UNSAFE & UNSUSTAINABLE

*Experts Review the Center for Sustainable Shale Development's
Performance Standards for Shale Gas Development*

Prepared for
the Delaware Riverkeeper Network

2014

Figure 7. Gas and contaminant excursion vectors from non-cemented and failed sheath borehole segments.

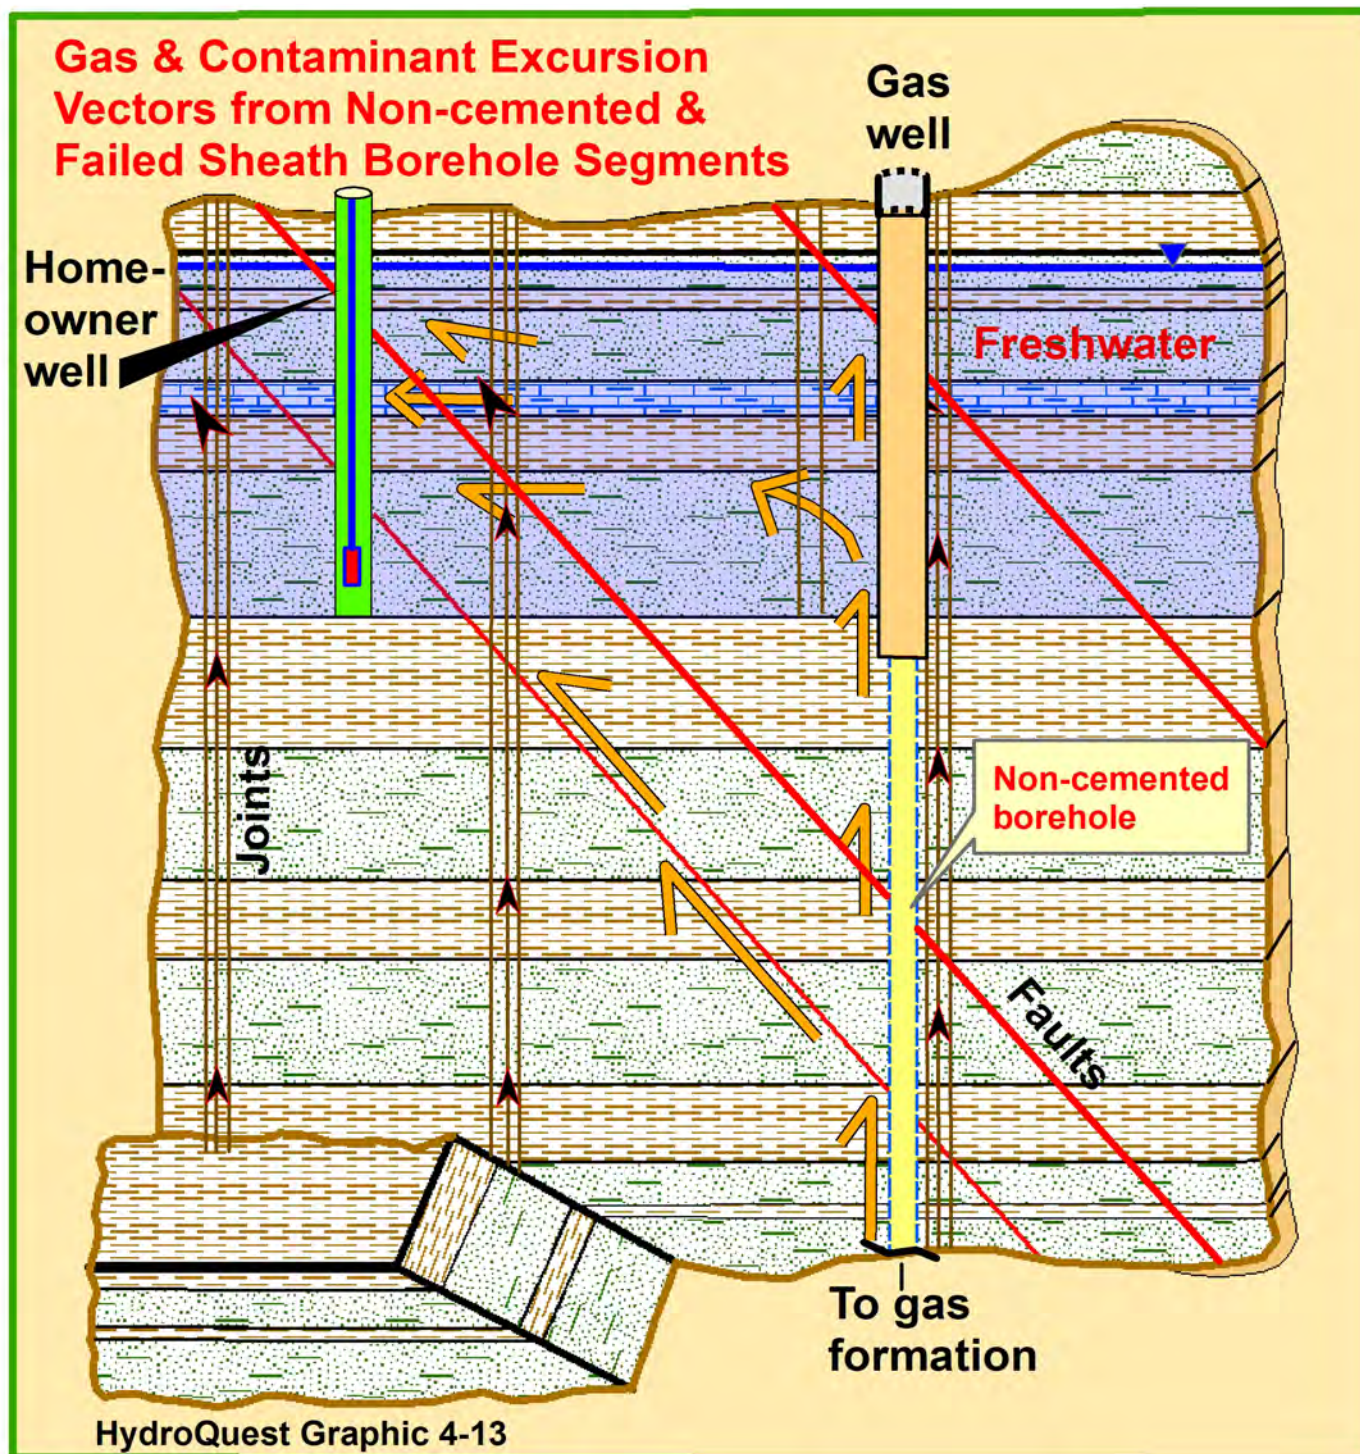
Distinctly lacking from Performance Standard 7 is any mention of time. Aquifer protection is needed well beyond the productive lifetime of gas wells. Also lacking is long-term durability of sealant materials used worldwide at this time. Low-durability wellbore sealant materials currently in use (cement and steel) have design lives of generally less than 100 years and are not capable of ensuring long-term protection of aquifers needed for future generations. Wellbores sealed with cement and steel do not provide reliable, long-term, downhole integrity, that will preclude chemical, gas, and contaminant migration along failed and open wellbores into freshwater aquifers (Figure 7).
